BEACON LITE ROAD STOCKPILE CONSTRUCTION DRAWINGS AMENDMENT

EDARP FILE NO.: CDR261

V5_Grading & Erosion Control (GEC) Plan_comments.pdf Markup Summary

GRADING & EROSION CONTROL PLAN

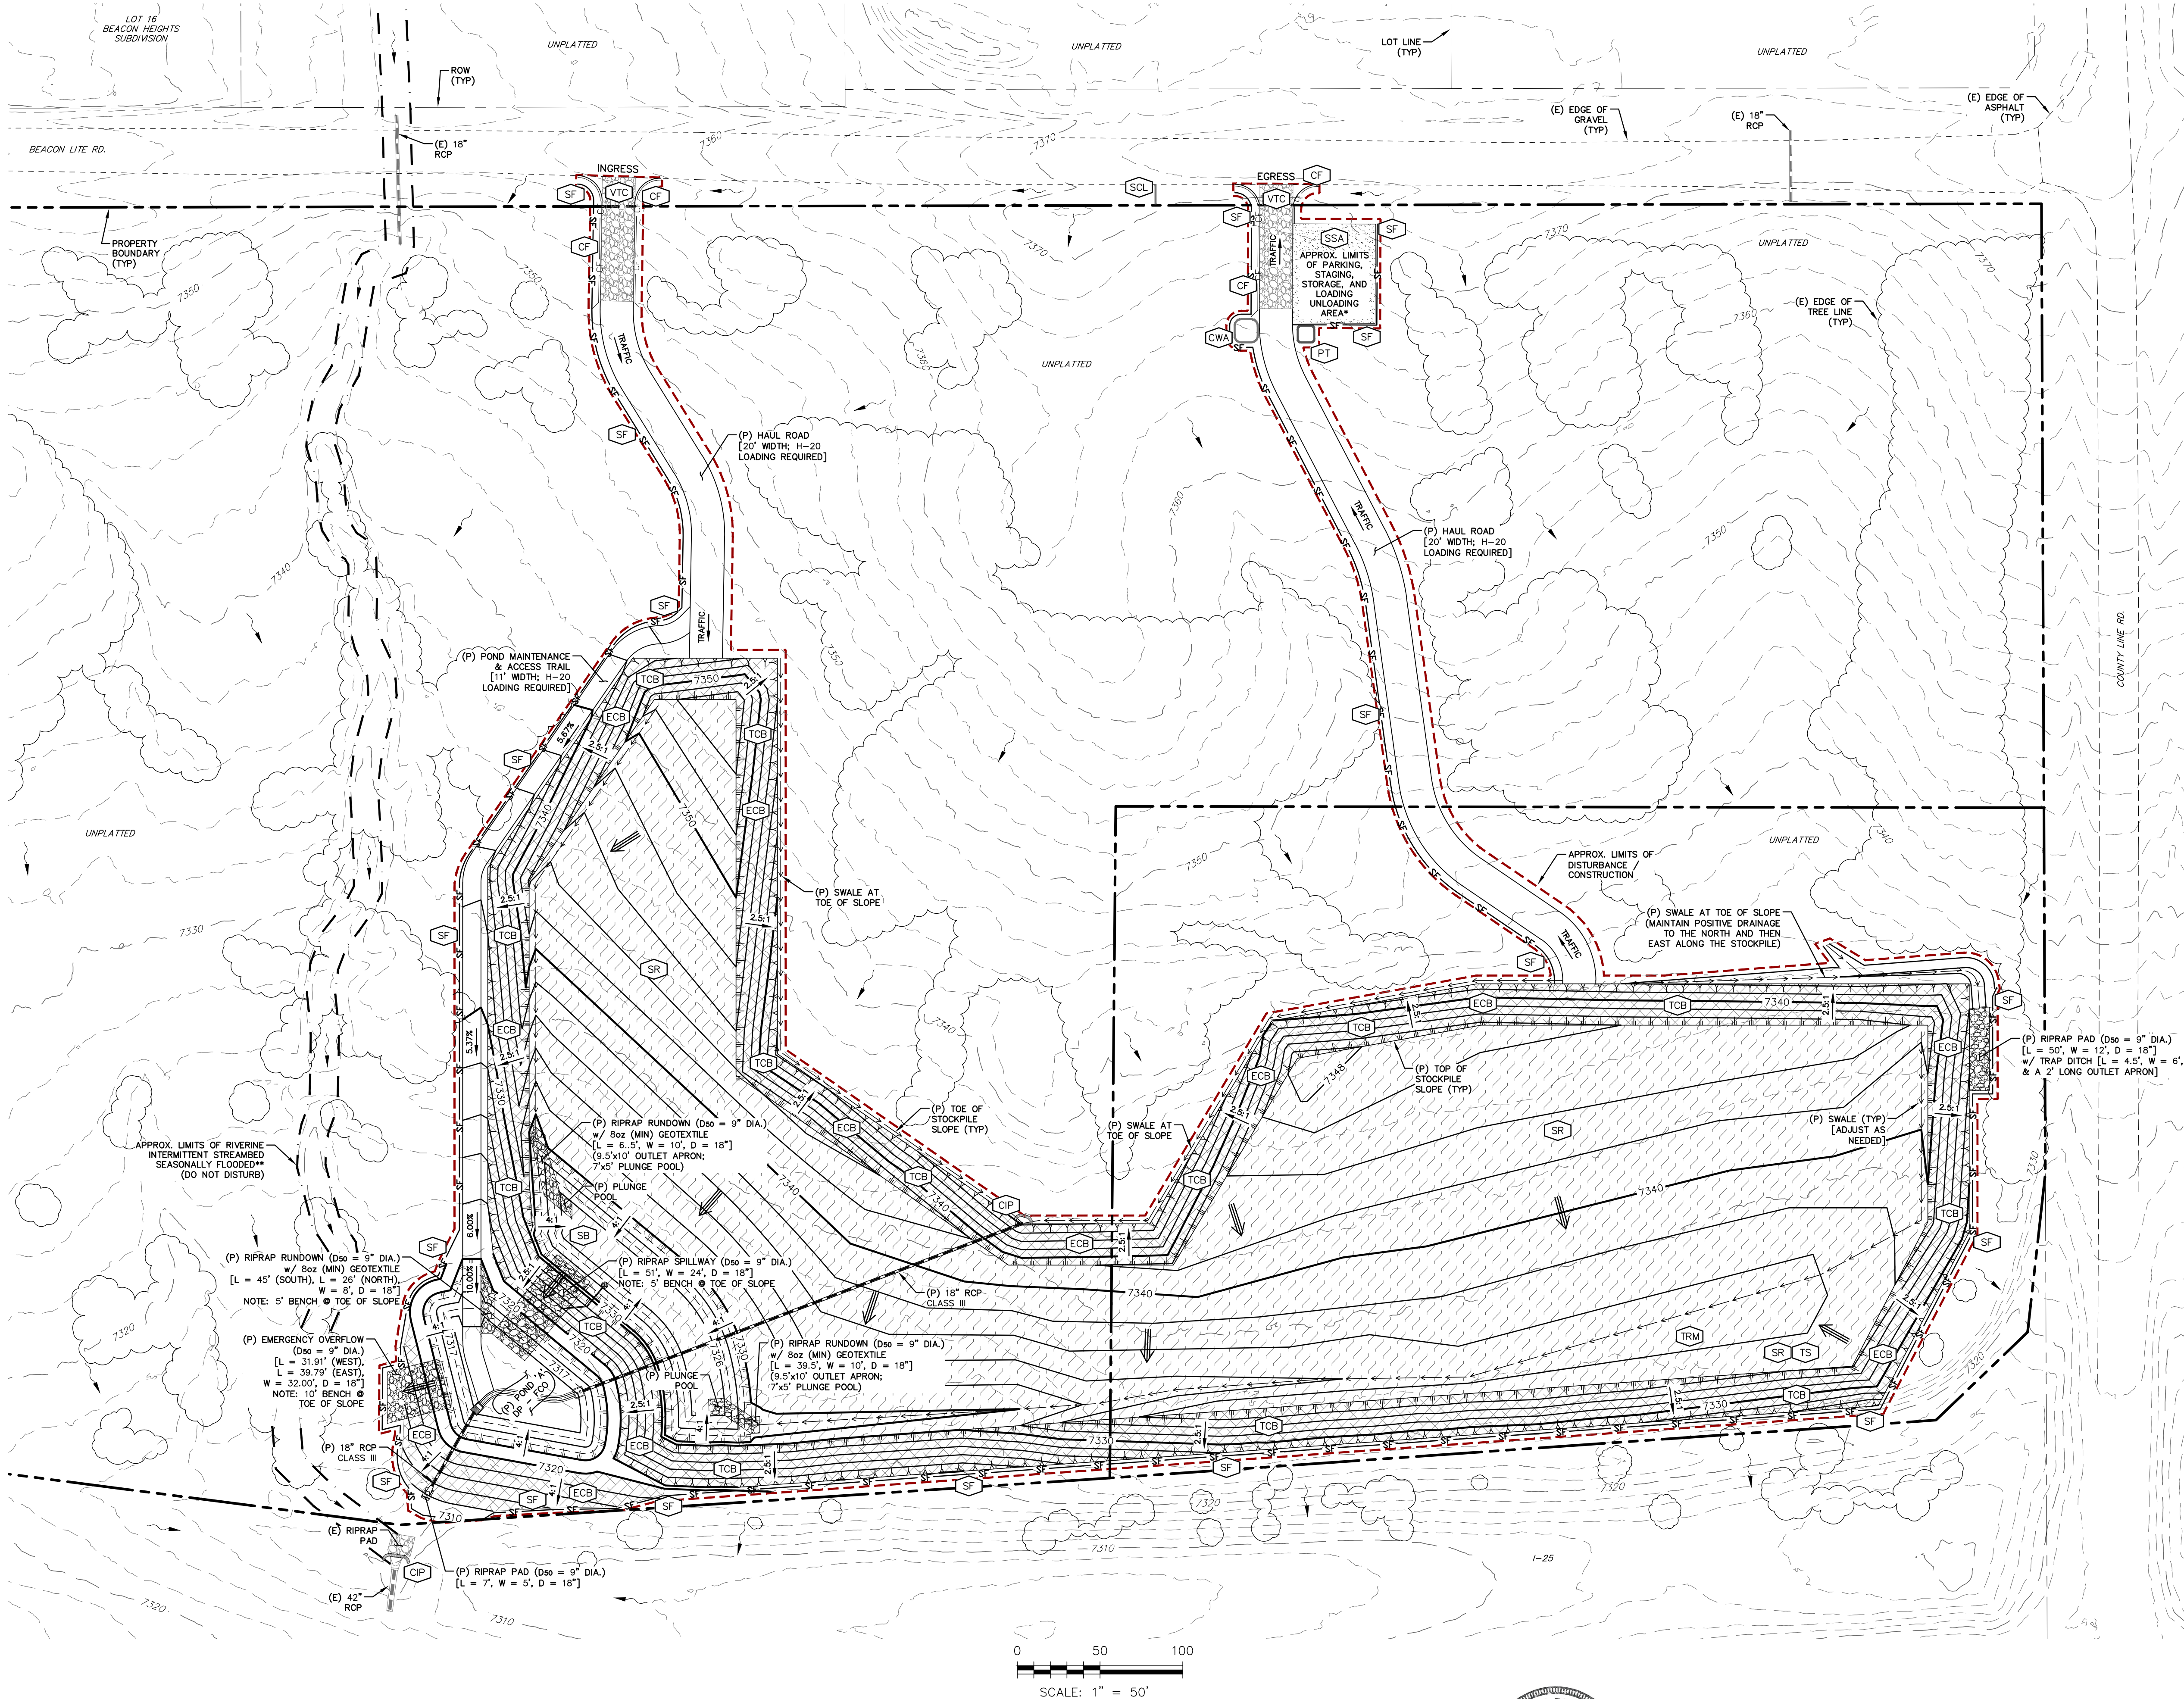
With your original email request to modify the stockpile, it was not made clear that you were going to need to add a PCM. Now that I know that's the plan, we will also need the following docs:

- Revised/new DMA
- PCM - Notice of Intent to Construct a Non-Jurisdictional Water Impoundment Structure (proof of submittal) --- just submit the PDF of the email showing you sent another form for the new pond to the State.

verify whether RCP and riprap need to be extended due to the new grading.

comments have been provided on the drainage report regarding conveyance and erosion at these concentrated outfalls. Revise as necessary

Added Silt
Fencing

PERMANENT CONTROL MEASURE PLAN

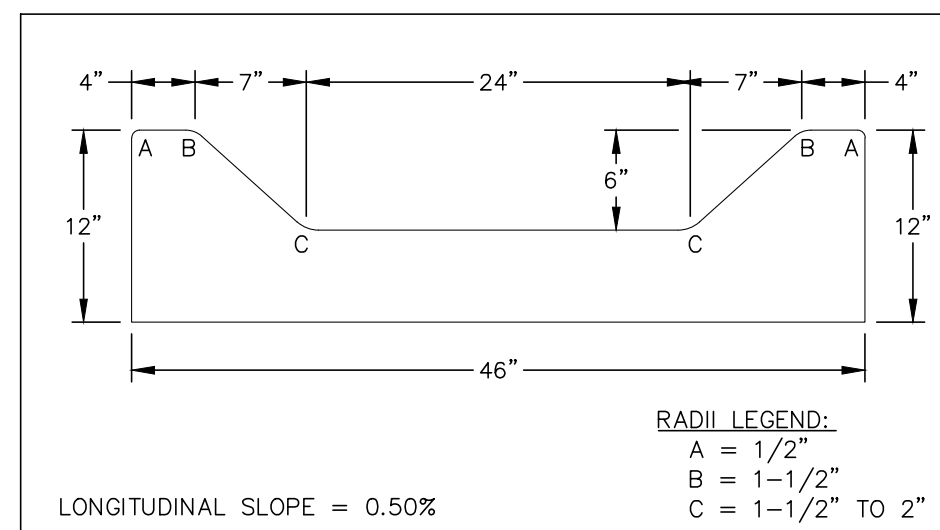
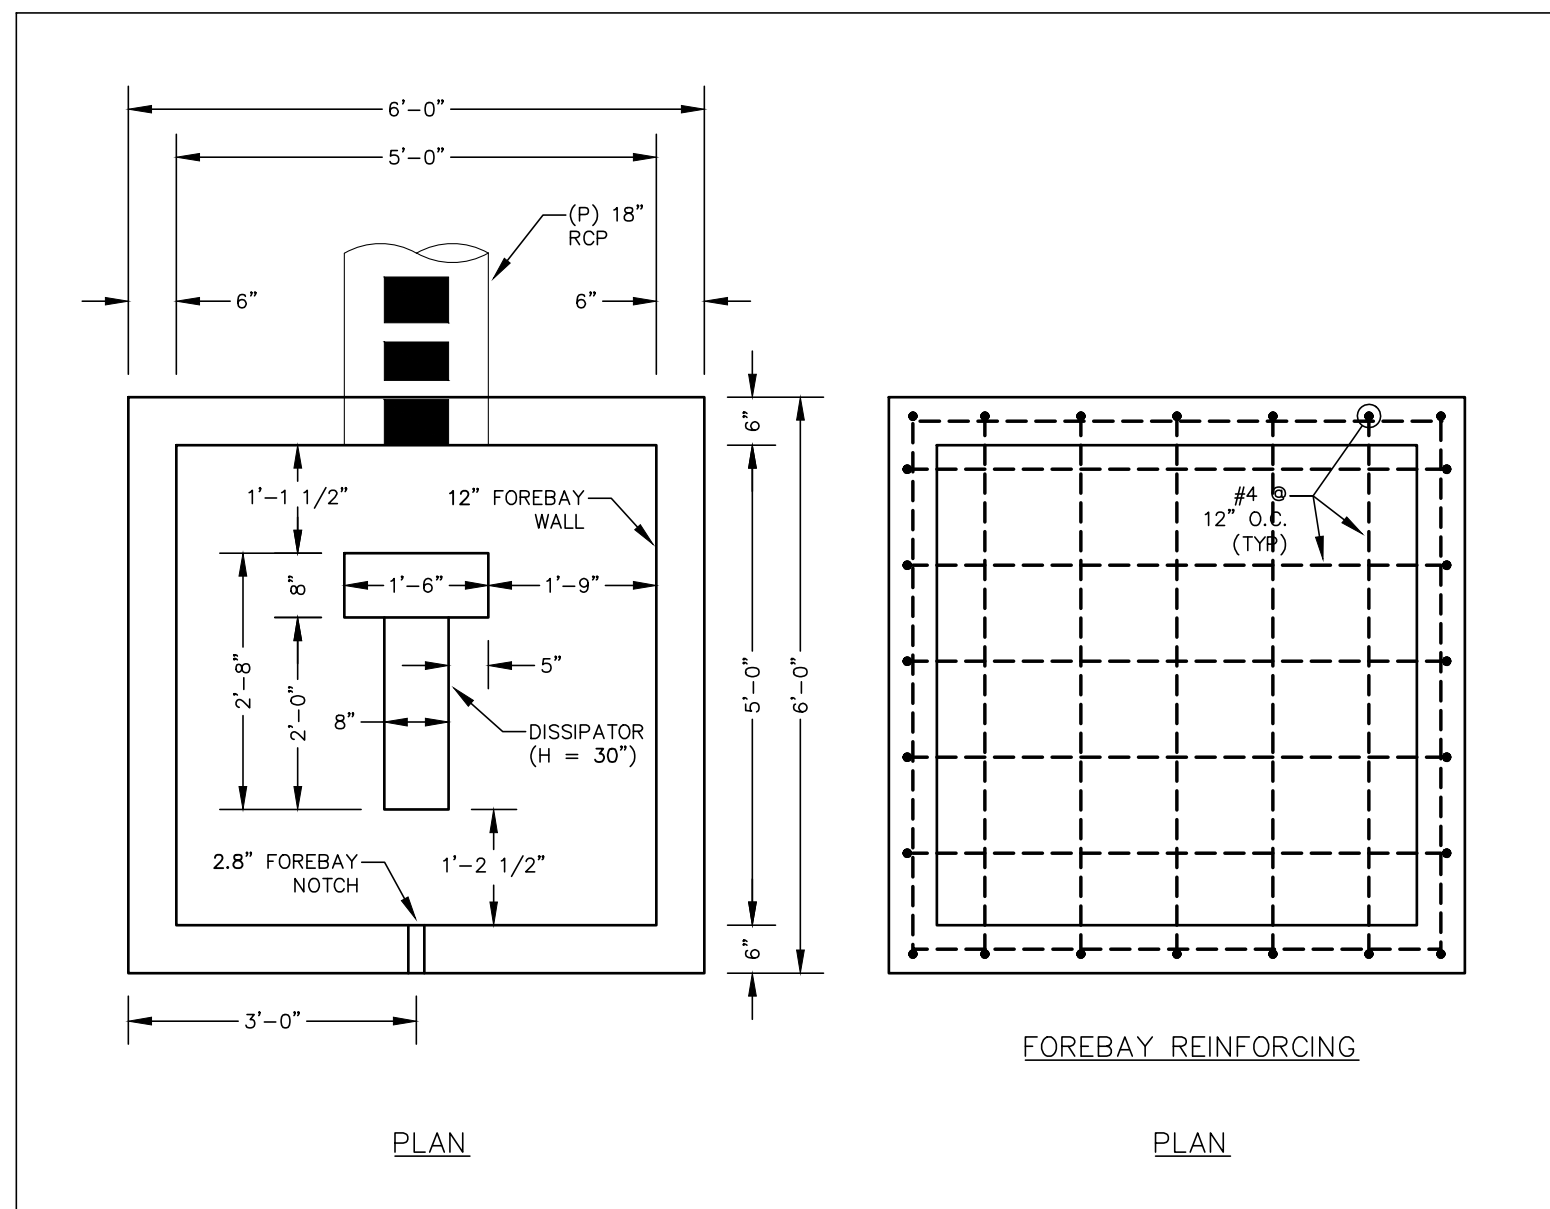
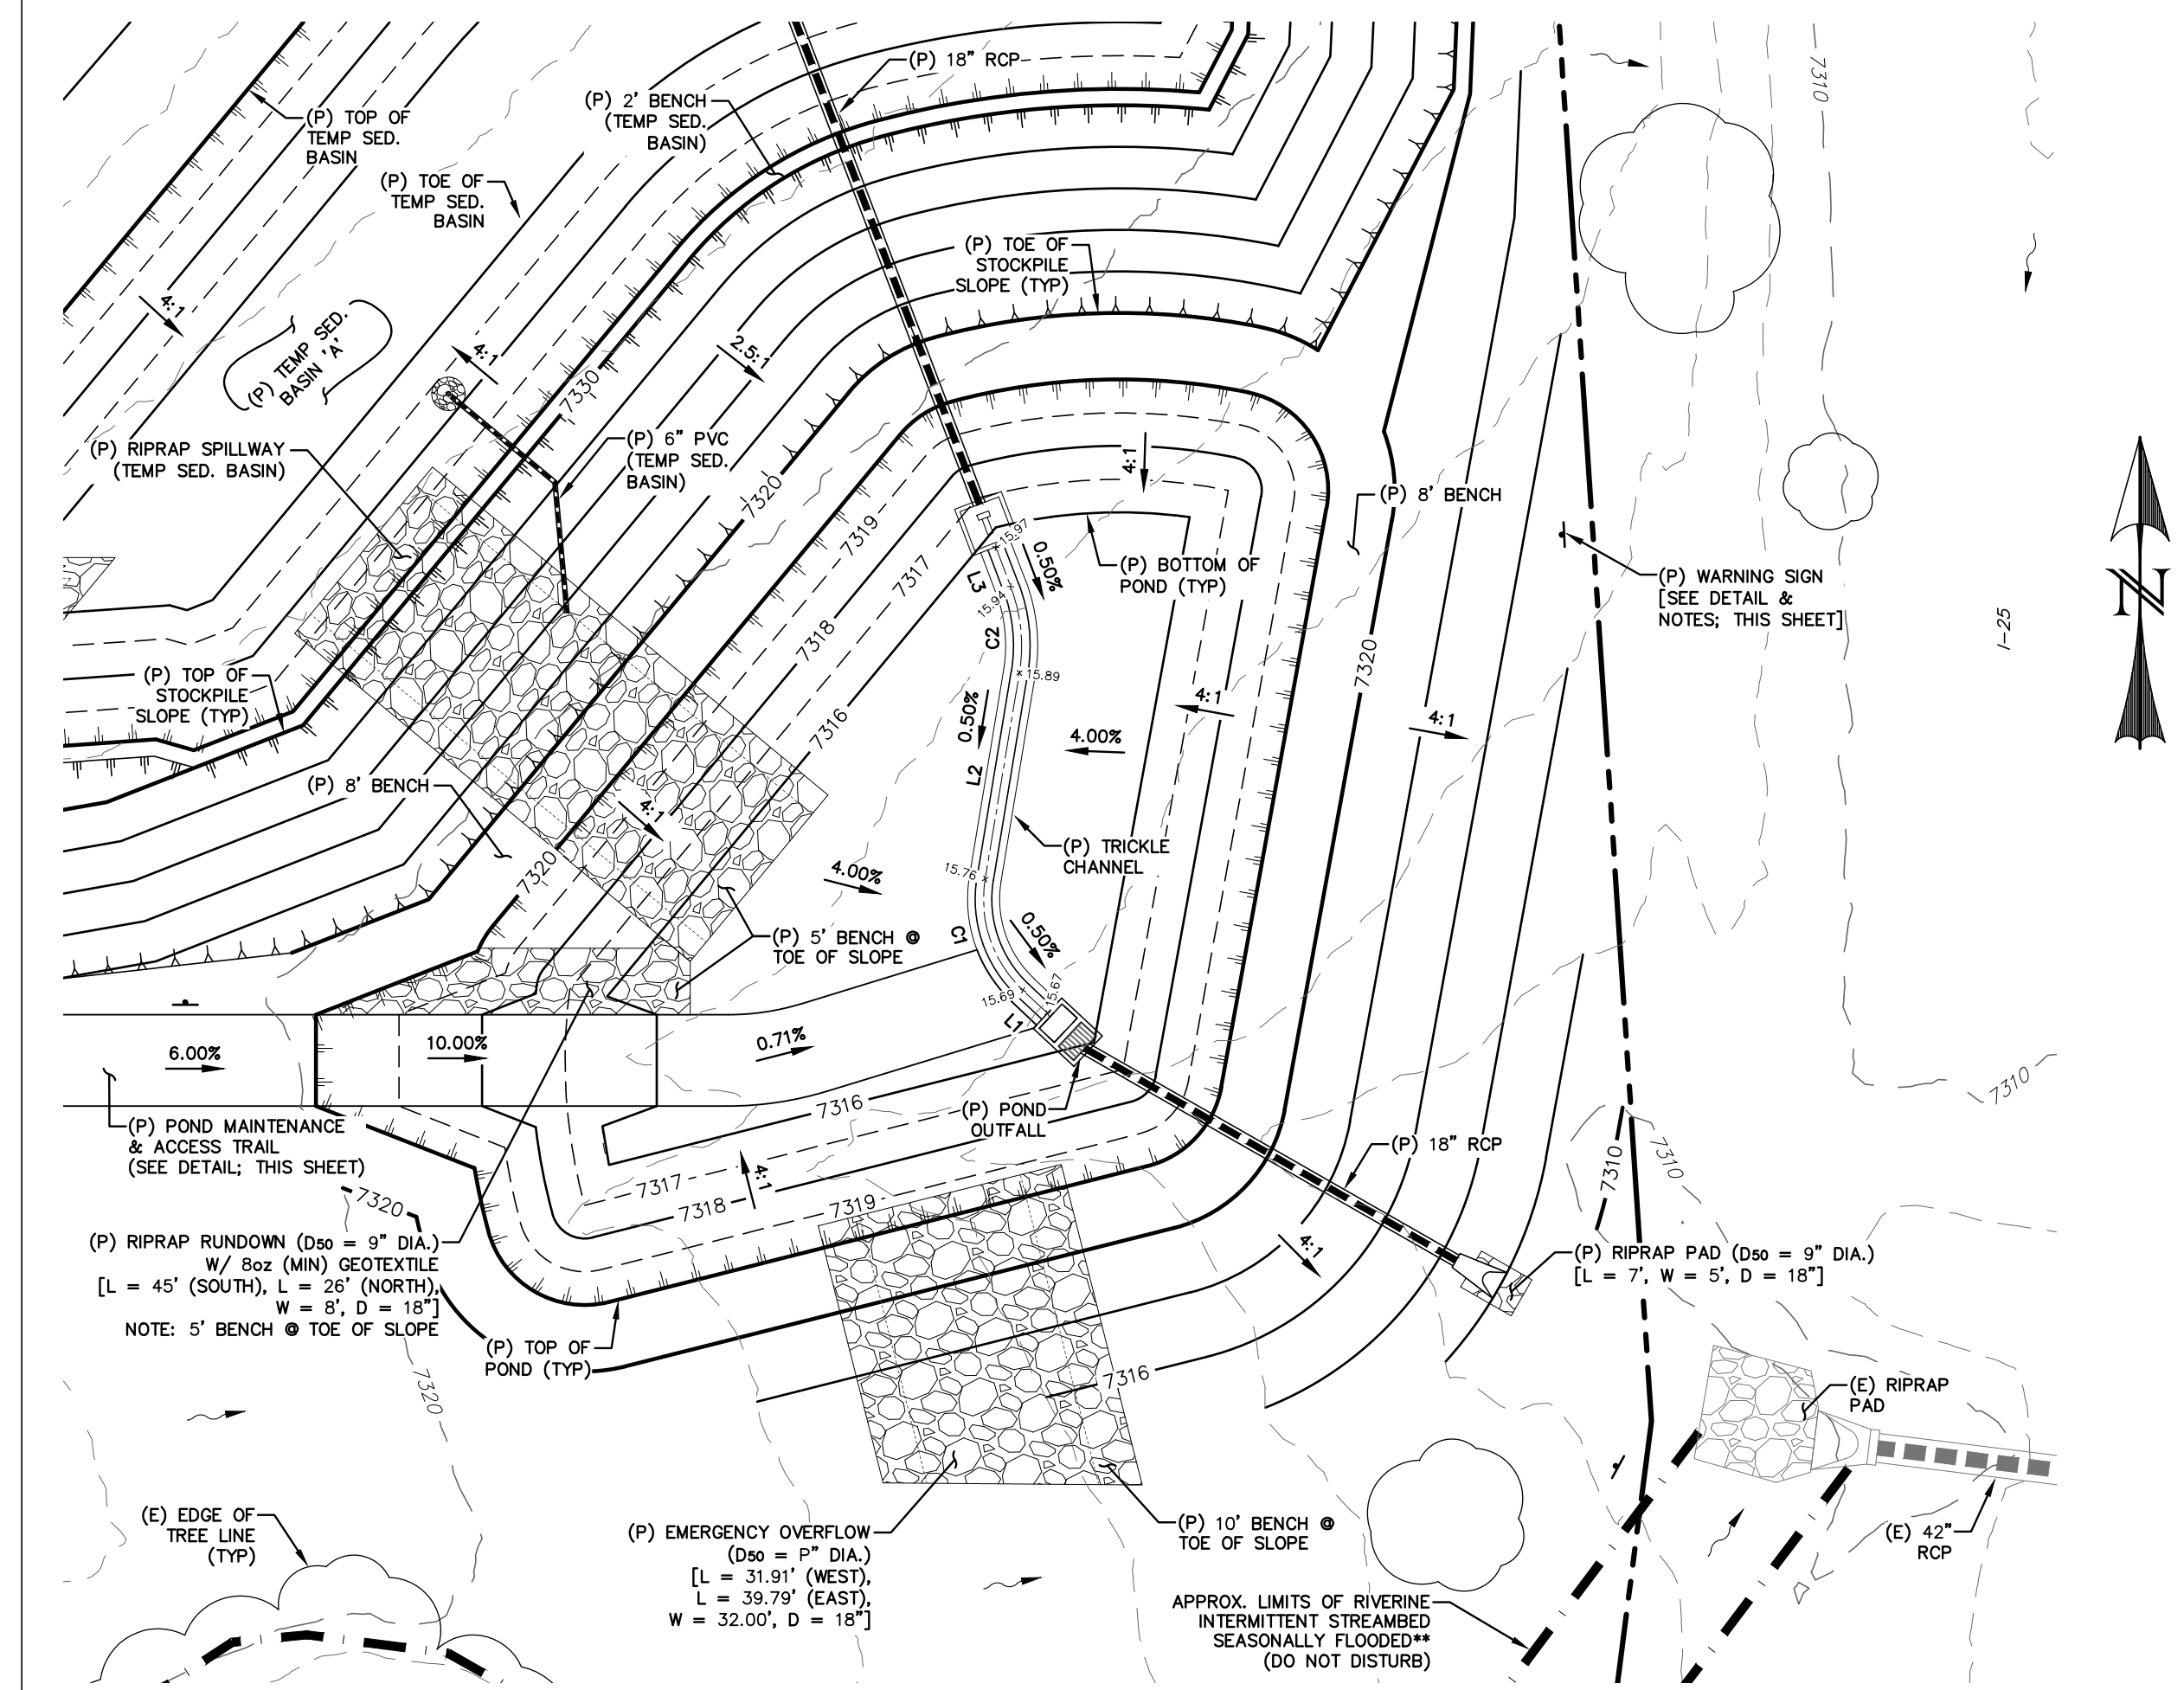
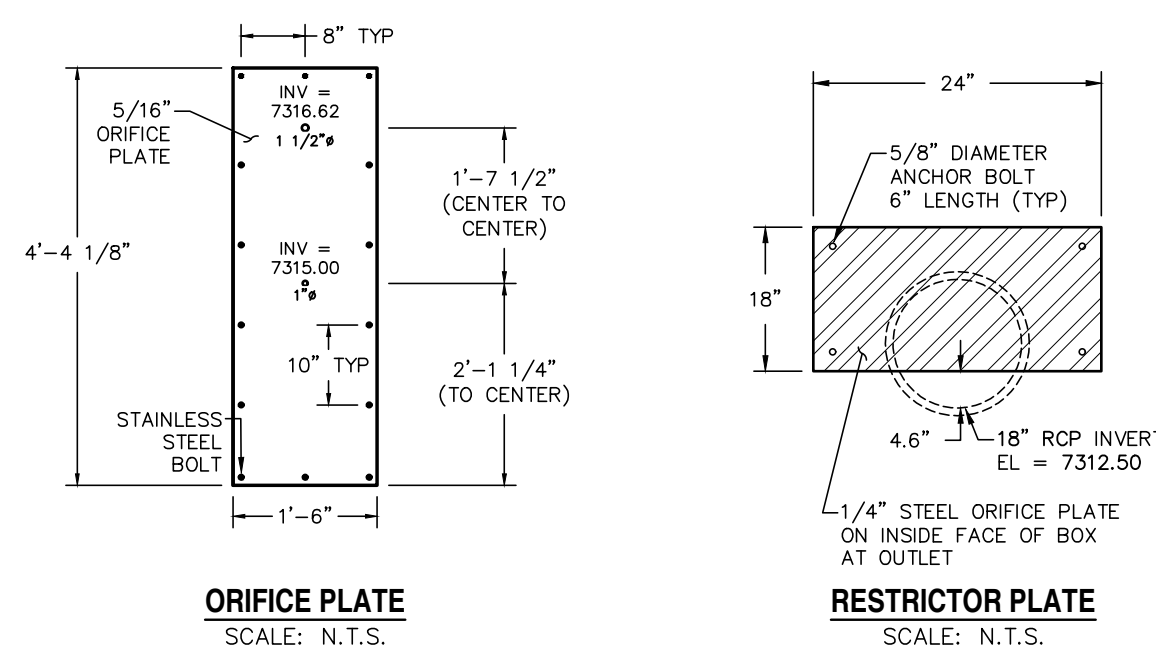
Revise text for size discrepancy. Calcs and detail in upper left of this sheet show 2.5'x4'

Please provide more detailed gasket info like thickness, width, brand/model, etc.

Please provide more detailed gasket info like thickness, width, brand/model, etc.

Revise text for size discrepancy. Calcs and detail in upper left of this sheet show 2.5'x4'

Added
Gasket
Note

The gasket shall be made of 1/4-inch thick, 60 durometer EPDM rubber in a continuous sheet the size of the orifice plate. The sheet shall be placed between the orifice plate and the concrete wall, with the width of the overlap between the plate and the concrete. Openings shall be cut into the sheet corresponding to the plate bolt holes and the concrete wall opening, cuts made either by the contractor in the field or by the manufacturer. Or equivalent gasket approved by EPC. Note that caulk is not an approved equivalent and will not be accepted by EPC.

Added
Gasket
Note

The gasket shall be made of 1/4-inch thick, 60 durometer EPDM rubber in a continuous sheet the size of the orifice plate. The sheet shall be placed between the orifice plate and the concrete wall, with the width of the overlap between the plate and the concrete. Openings shall be cut into the sheet corresponding to the plate bolt holes and the concrete wall opening, cuts made either by the contractor in the field or by the manufacturer. Or equivalent gasket approved by EPC. Note that caulk is not an approved equivalent and will not be accepted by EPC.
